RE: COUNTY OF MENDOCINO, DEPARTMENT OF TRANSPORTATION
LAMBER LANE BRIDGE REPLACEMENT ACROSS ROBINSON CREEK
IN MENDOCINO COUNTY
DOT CONTRACT NO. 230001
PROJECT ID B1302
FEDERAL AID PROJECT NO. BRLO-5910(099)

COUNTY OF MENDOCINO, DEPARTMENT OF TRANSPORTATION
ACKERMAN CREEK BRIDGE REPLACEMENT ON NORTH STATE STREET
CR 104, MILE POST M.P. 0.97
DOT CONTRACT NO. 200093
DOT PROJECT NO. A1101
FEDERAL AID PROJECT NO. BHLS-5910(081)

ADDENDUM NO. 1

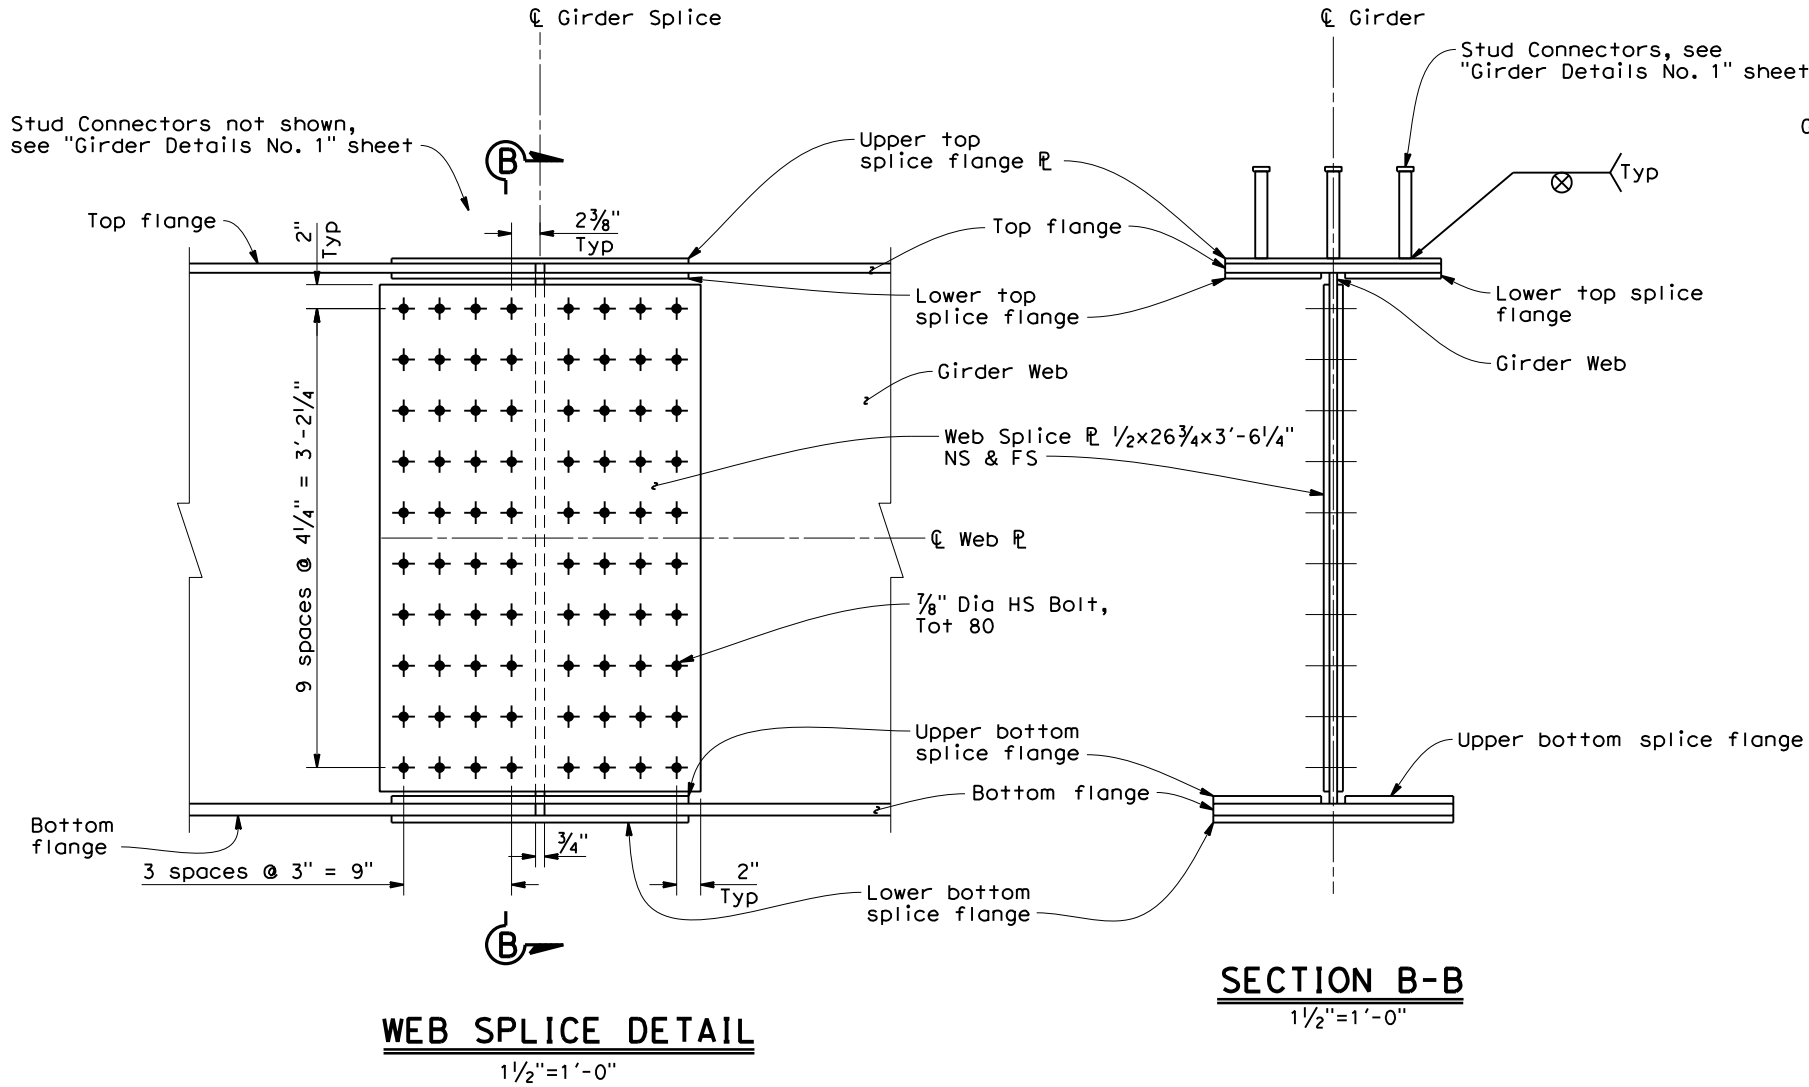
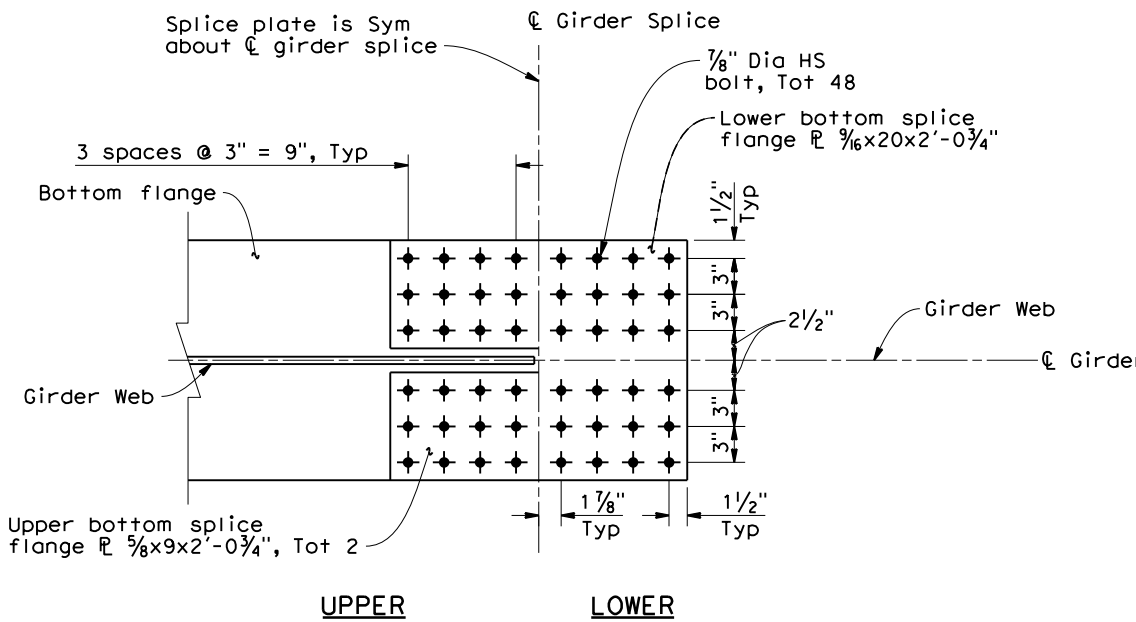
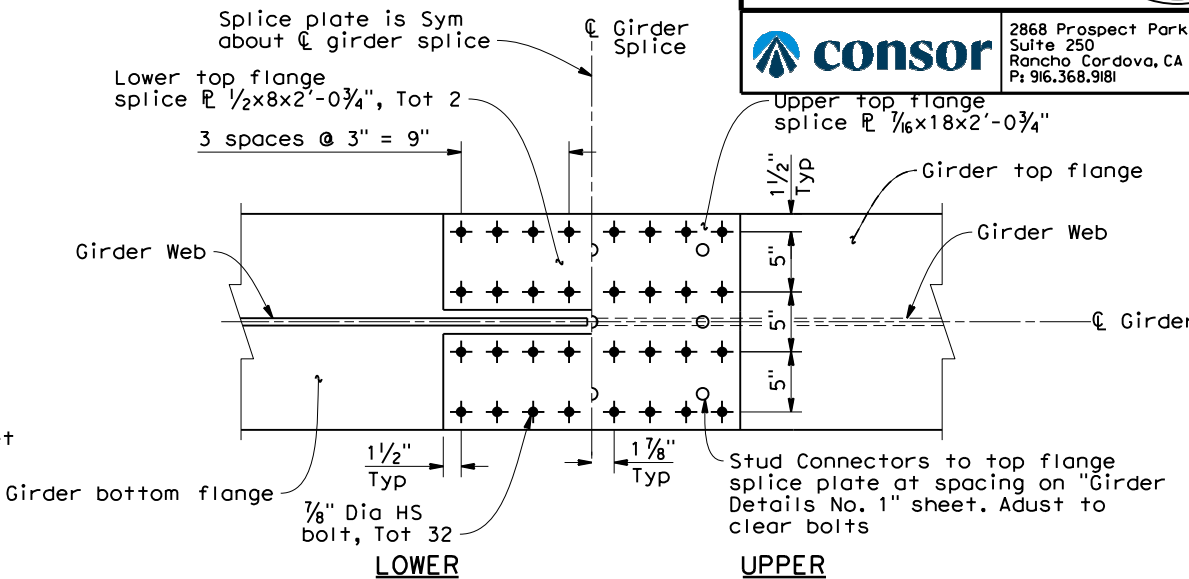
- Plan sheet 28 of 42 (Deck Contours): Revisions were made to the materials specification for steel in the Design Notes.
- Plan sheet 35 of 42 (Girder Layout): Location of the Drip Plate Detail and Limits of Girder end painting were added.
- Plan sheet 37 of 42 (Girder Details No. 2): A detail was added for painting faying surfaces with a Class B coating for the optional bolted splice.
- Plan sheet 39 of 42 (End Frame Details): Drip Plate Detail was added.

REVISED PER ADDENDUM No. 1, DATED APRIL 11, 2025

1. All contact surfaces between steel plates shall be blast-cleaned and coated with Class B coating to the limits shown.
2. All HS bolts used for girder splices shall be F3125 Grade A325 Type 3.

1 DRIP PLATE DETAILS
EXTERIOR GIRDERS
No Scale

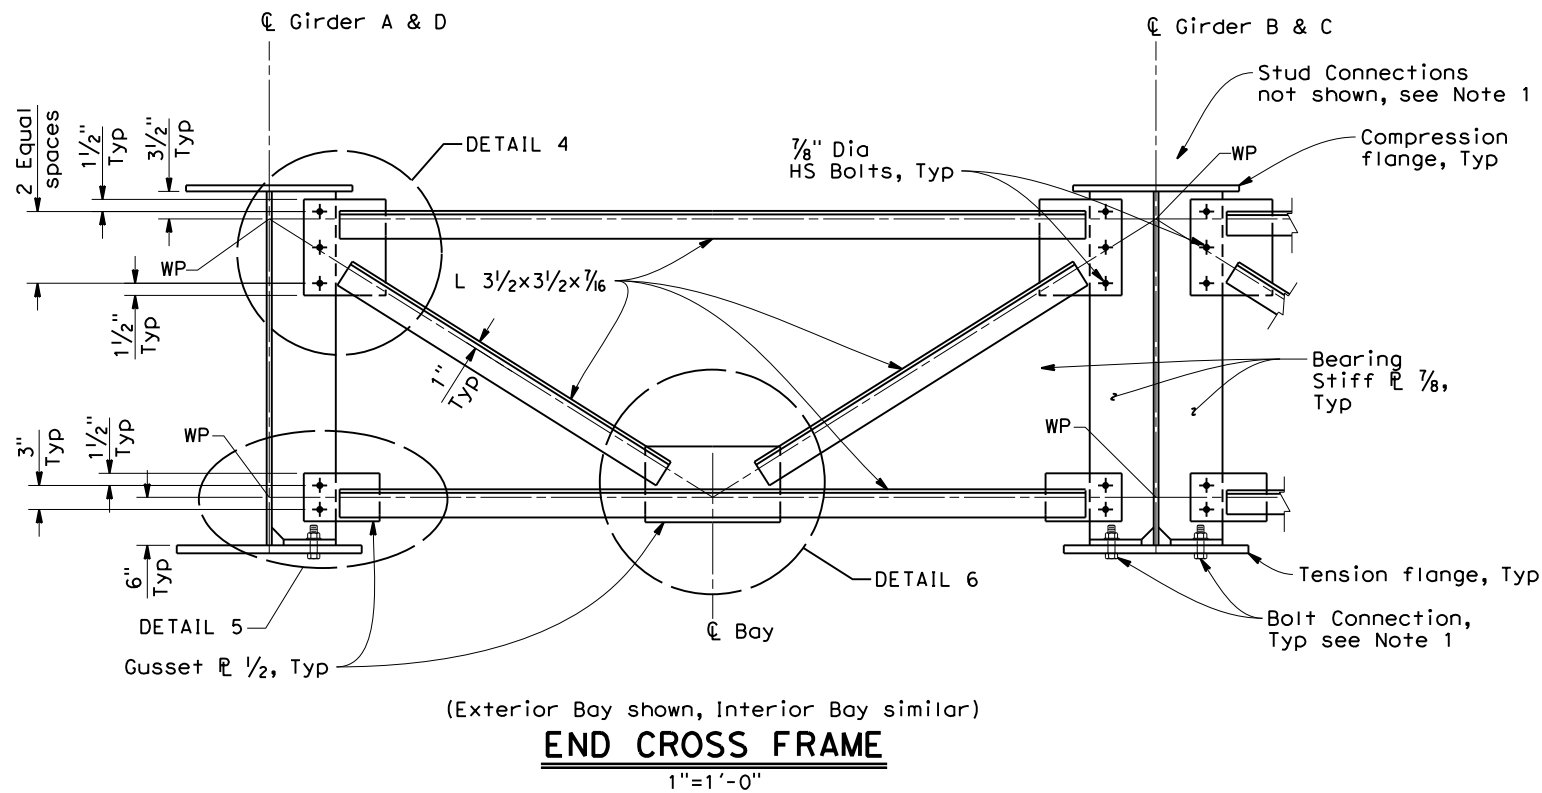
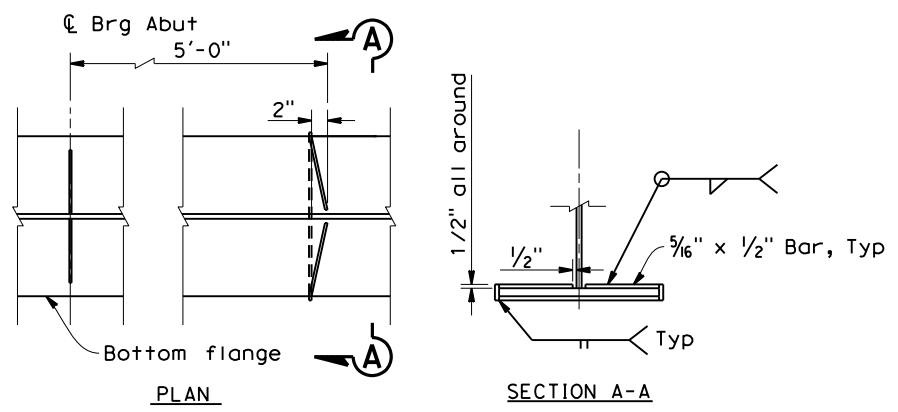
1 REVISED PER ADDENDUM No. 1, DATED APRIL 11, 2025
